I am reviewing the plans submitted for 257 Brighton Avenue and have the following plan review comments:

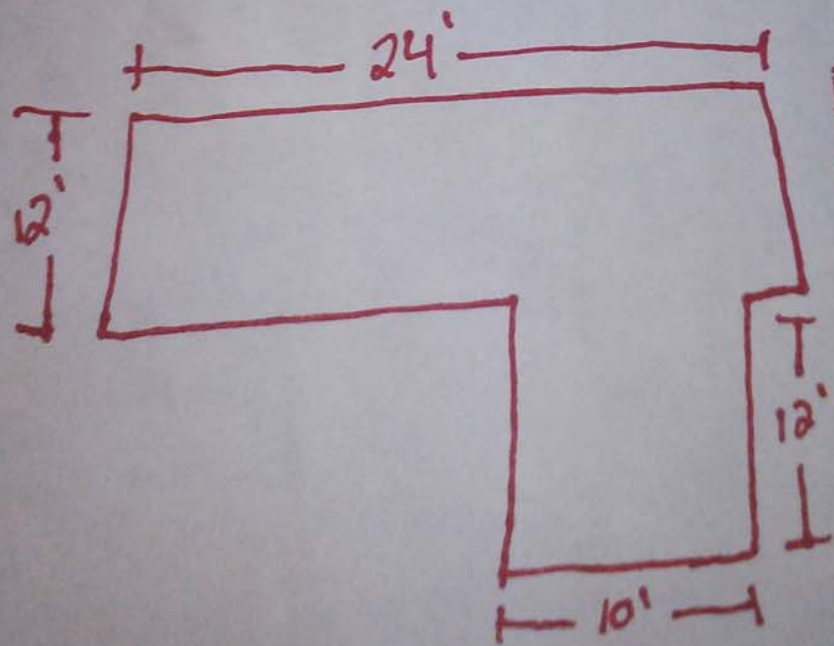
- Provide emergency escape and rescue opening per R310 for habitable attics.
- Clarify what the existing conditions are for the exterior walls and ceilings in the attic space. What is the existing insulation for the walls and ceilings? Provide R value for proposed insulation. *No Existing Insulation, wall + ceilings will be 2x6 Frame*

- Provide proposed GWB on walls and ceiling. *1/2 inch Gyp Board*
- Provide stair rise and run of existing stairs to attic space per R311.7.4. *7 3/4 x 10*

- Provide headroom of stairs to attic per R311.7.2. *71" existing, will be framed to 6'8"*
- Provide width of existing stair to attic space per R311.7. *35"*

- Provide handrail height and dimensions per R311.7.7. *None Existing new railing will comply*
- Provide CO and smoke alarms per R314 and R315. *They will be installed per code*

- Clarify the ceiling height throughout the entire attic space per R305.1.

*Existing 22" off floor
R38*

Ceilings throughout will be atleast 7' and over 50 percent of floor space

Dimensions from inside of knee walls.

65% of overall floor space will be over 7'
